Your ref:  
Our ref: 1-38-4325/4

Re: 42 Elsworthy Road, London, NW3 3DL

A brief report is requested to summarize the arboricentric approach which should be adopted and is proposed.

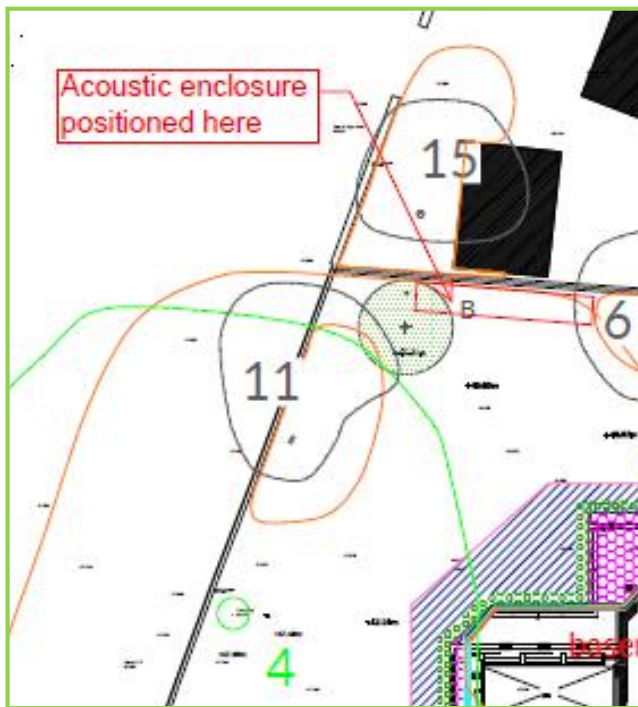
Big Foot is essentially a rooftop support system using synthetic bases designed for acoustic enclosures, etc., and where spreading of load is important. Typical application illustrations from the company's website show slabs used, in turn, to support the bases. In this proposed application at the above address an apparently lightweight enclosure is needed on the northwest boundary .

I see no reason to consider that a very simple shallow foundation such as slabs bedded on a porous substrate entailing no excavation will be damaging to tree 4, the large and visually highly important London plane tree to the SW within the root protection area of which the enclosure is proposed. It is essential, to avoid significant root damage, that Method 8 is followed carefully.

For the avoidance of doubt, 'B' is a proposed tree and no negative impact on growth or establishment of this tree as a result of the proposals is envisaged.

This method shall apply in the zone **outlined red** above on plan extract. Edge restraint shall be formed from tanalised timber pegged or pinned to substrate with 25mm dia. re-bar or similar. A geogrid such as Tensar 'TriAx' shall be laid directly on the ground surface within the timber edges (NO turf or soil stripping whatever shall take place), then a sub-base 75mm deep of 20-40mm clean stone -NO FINES-(typically sold as 'track ballast'), then a 2D geotextile such as 'Ekotex'. A blinding of granite chippings may be laid to correct levels, then the slabs. The slabs shall not be bedded on mortar or lean mix.

Big Foot support system shall be erected directly on the slabs over chippings and geotextile, or, if in accord with manufacturers' design, directly on the substrate of clean stone.
